**RUSSELL VALE COLLIERY  
REVISED UNDERGROUND  
EXPANSION PROJECT**

Submissions Report – Part B

Prepared by  
**Umwelt (Australia) Pty Limited**  
on behalf of  
**Wollongong Coal Limited**

**Figure 9-1 Predicted Pressure Head and Potentiometric Head Initial Conditions at Russell Vale East (North – South Cross Section on Easting 303000)**

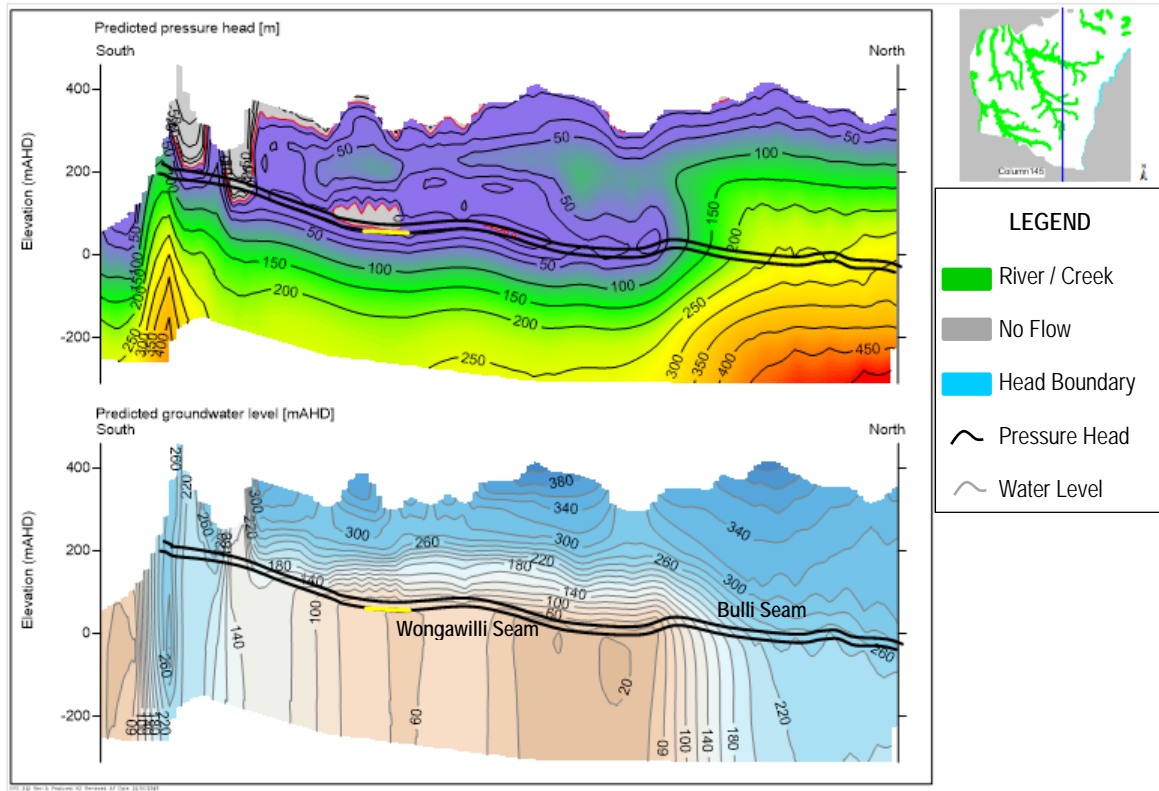
- c. The schematic presentation of the conceptual model (Figure 9-1) is largely illegible and contains fundamental errors. For example, the springs shown on the right hand side in Figure 9-1 are hydrogeologically impossible.**

**c. The schematic presentation of the conceptual model (Figure 9-1) is largely illegible and contains fundamental errors. For example, the springs shown on the right hand side in Figure 9-1 are hydrogeologically impossible.**
